MONTGOMERY COUNTY HISTORIC PRESERVATION COMMISSION
STAFF REPORT

Address:	15 Hesketh St., Chevy Chase	Meeting Date:	1/22/2020
Resource:	Contributing Resource Chevy Chase Village Historic District	Report Date:	1/15/2020
Applicant:	Deanne Ottaviano & David Evans (Shawn Buehler, Architect)	Public Notice:	1/8/2020
Review:	HAWP	Tax Credit:	n/a
Case Number:	35/13-20B	Staff:	Dan Bruechert
PROPOSAL:	Deck Alteration, Door Installation, Chimney Removal

1 EXISTING REAR ELEVATION
Scale: 1/4" = 1'-0"

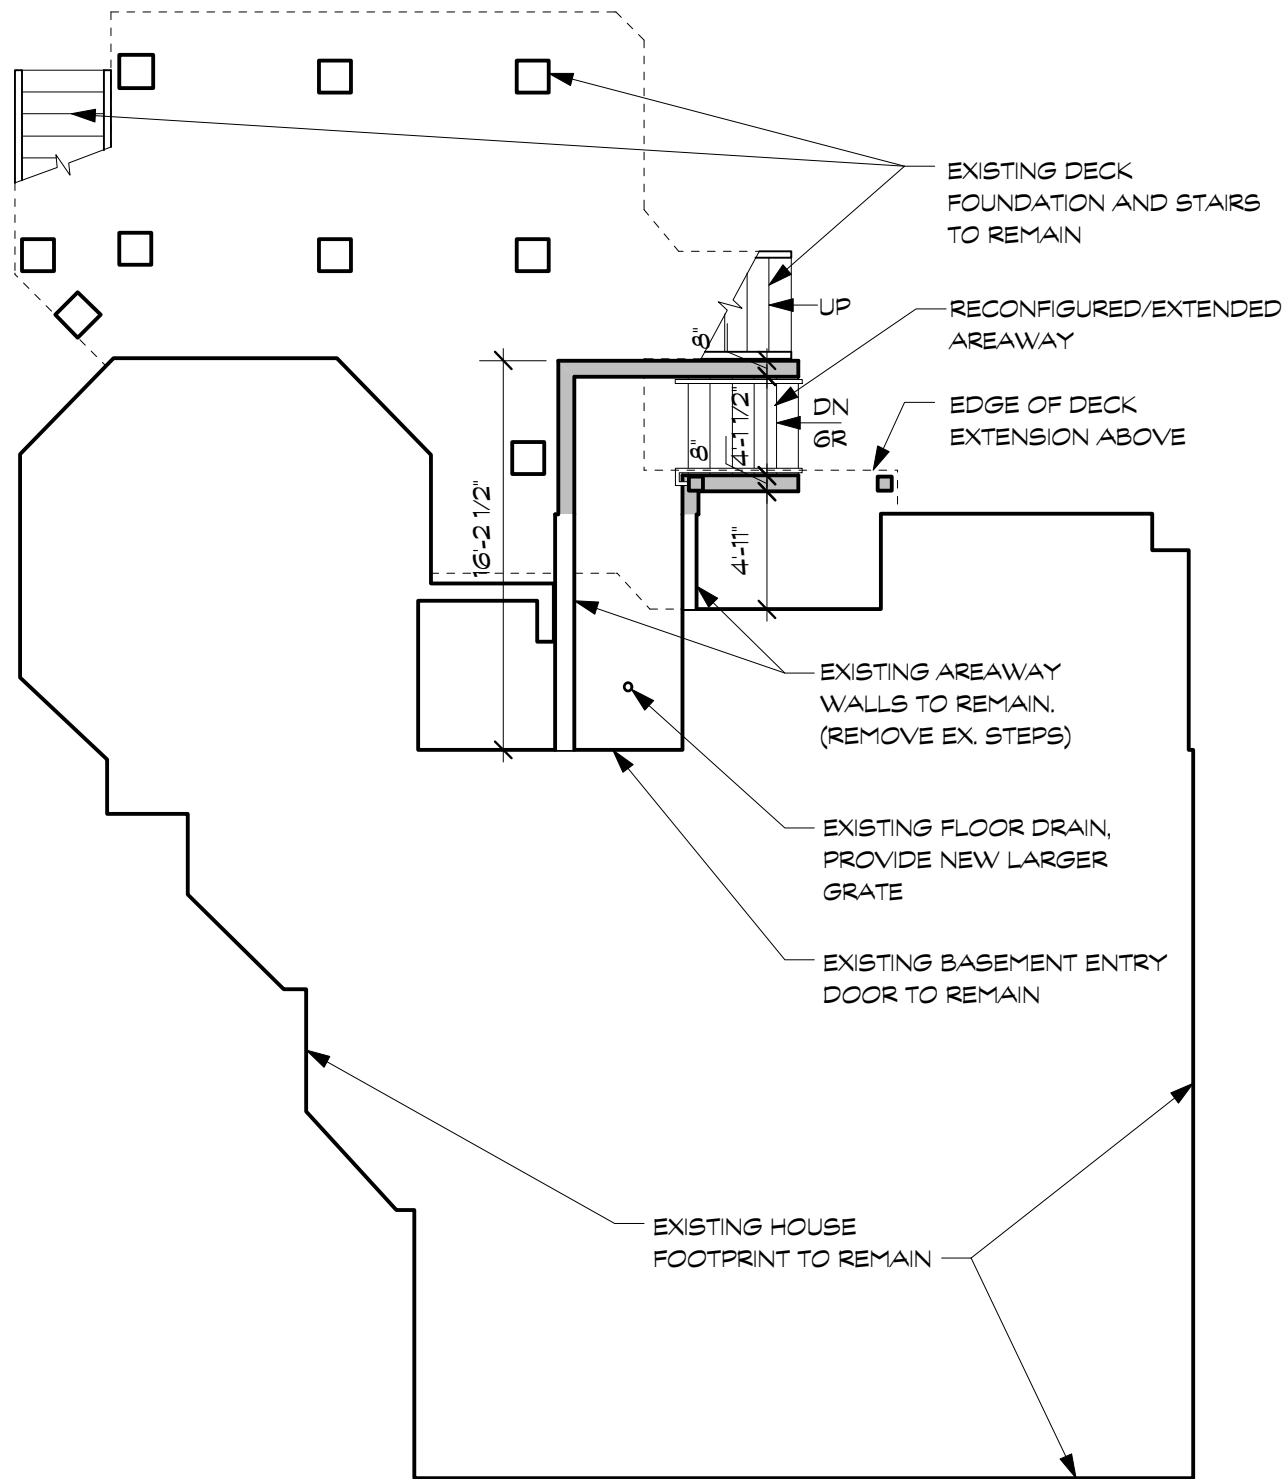
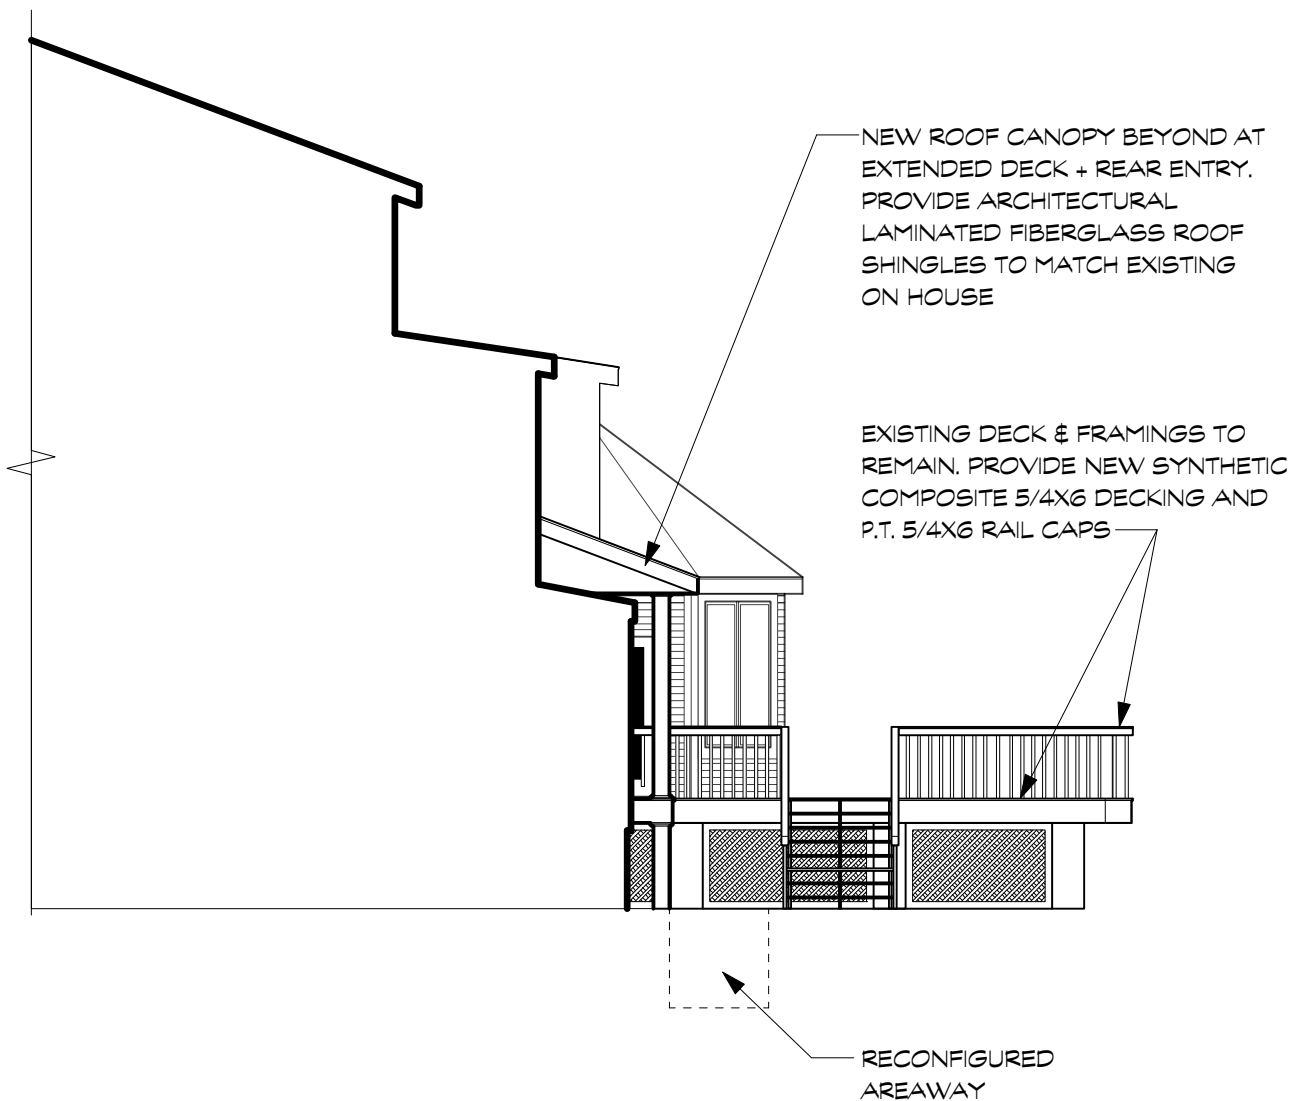
The existing deck is a non-historic feature that appears to have been constructed at the same time as one of the rear additions. The proposed work will extend the deck adjacent to the rear of the house by approximately 10' (ten feet). This installation will occur above an existing areaway and a new access point to the basement will be added below the deck. The new deck detailing will match the existing, simply detailed, rear deck and railing. The applicant also proposes to introduce a metal shed roof at the rear of the house which will project from between 3' and 4' (three and four feet) from the rear wall. The roof will be supported by 6" × 6" (six inch by six inch) square post, wrapped in Boral trim. Staff finds that in this application, Boral, an extruded substitute material, is appropriate as it is millable and paintable on a feature that is not visible from the surrounding historic district. Staff finds that the proposed work is compatible with the existing and will not be visible from the surrounding district and its approval is supported by 24A-8(b)(2).

The applicant further proposes installing a new aluminum-clad wood, full-light door in an existing window opening. Staff finds the expanded decking and new door proposed are appropriate for two primary reasons. First, the change is at the rear and is not visible from the public right-of-way. The *Design Guidelines* state that this alteration should be subject to a very lenient review. Second, the rear of the house has been added on to and modified to the point that the rear of the house retains very little historic integrity. This new door will not impact the historic character of the house in a significant way, consistent with 24A-8(b)(2) and the *Design Guidelines*.
